PIC18FXX2 Rev. C0 Silicon/Data Sheet Errata

The PIC18FXX2 Rev. C0 parts you have received conform functionally to the Device Data Sheet (DS39564B), except for the anomalies described below.

Clarifications/Corrections to the Data Sheet:

FIGURE 1: PINOUT DIAGRAM FOR PIC18F442/452, 44-PIN QFN PACKAGE

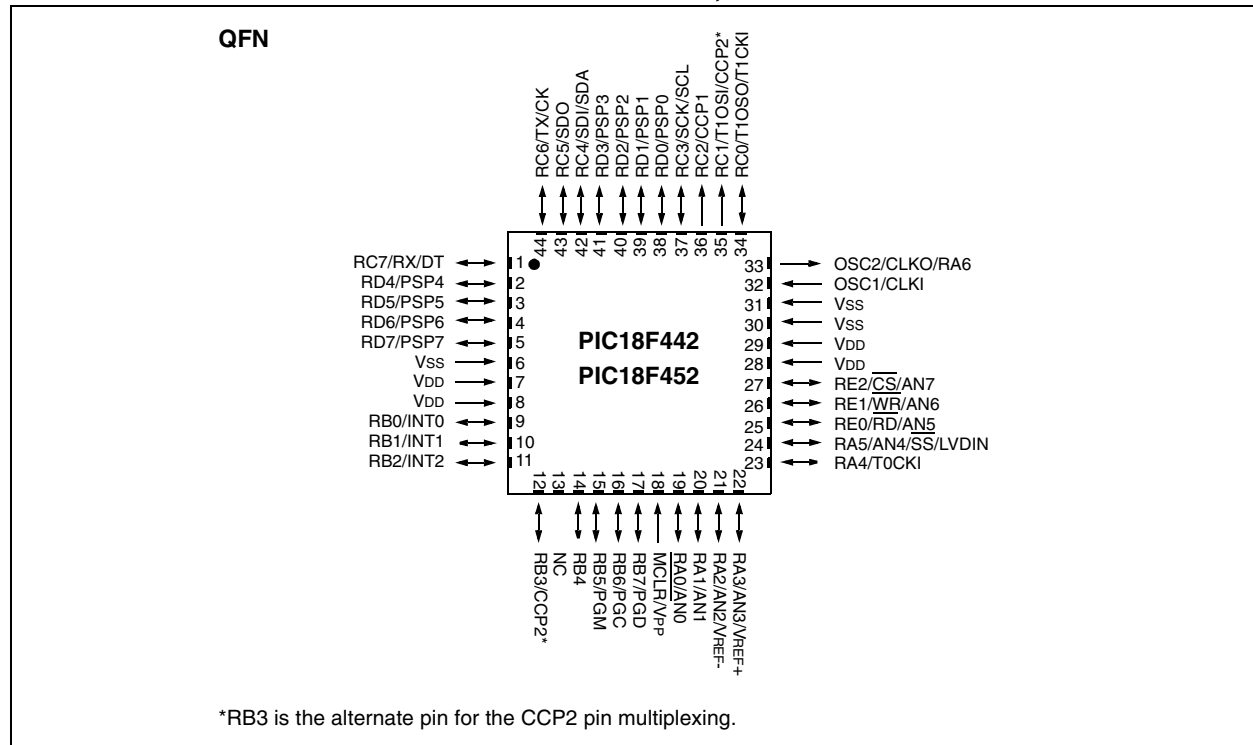
1. The “Pin Diagrams” on pages 2-3 of the Data Sheet are amended with the addition of the 44-pin QFN pinout, shown in Figure 1.
2. Table 1-3 of **Section 1.0 “Device Overview”** is replaced with an updated version which adds a column for QFN pin assignments. A row is also added for previously unlisted NC pins. All new information is indicated in **bold**.

FIGURE 2: PACKAGE MARKING TEMPLATE FOR PIC18F442/452, 44-PIN QFN

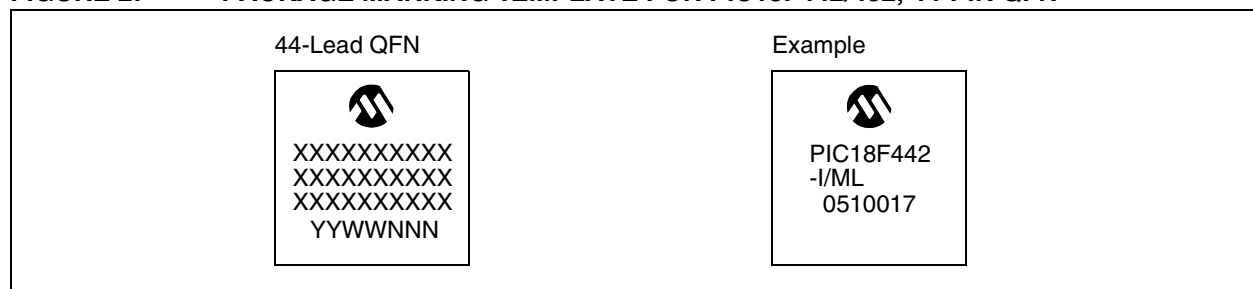
3. **Section 24.1 “Package Marking Information”** is amended to include a marking template and example for 44-pin QFN devices. These are shown in Figure 2.

FIGURE 3: 44-PIN QFN PACKAGE

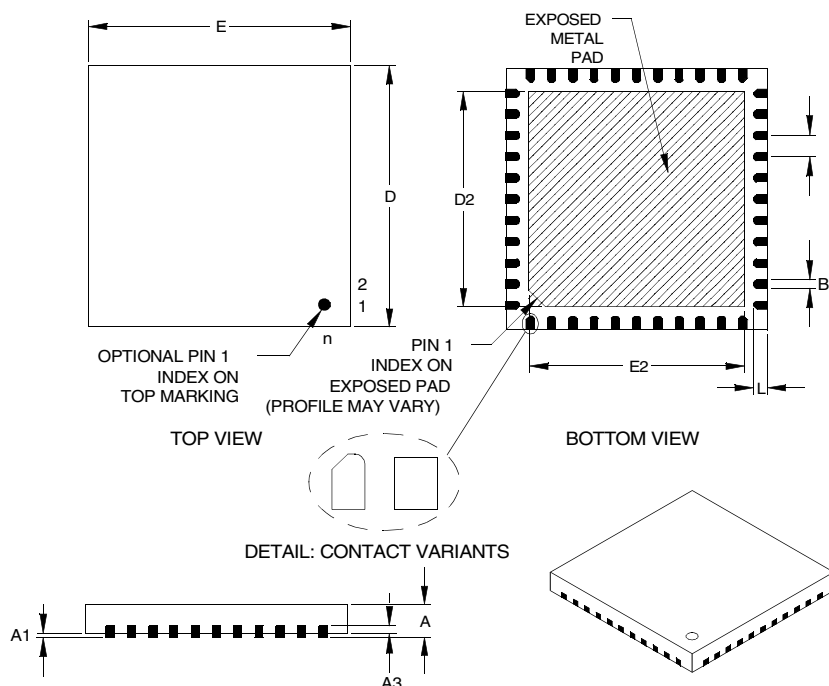
4. **Section 24.2 “Package Details”** is amended to include the mechanical drawing of the 44-pin QFN package, shown in Figure 3.
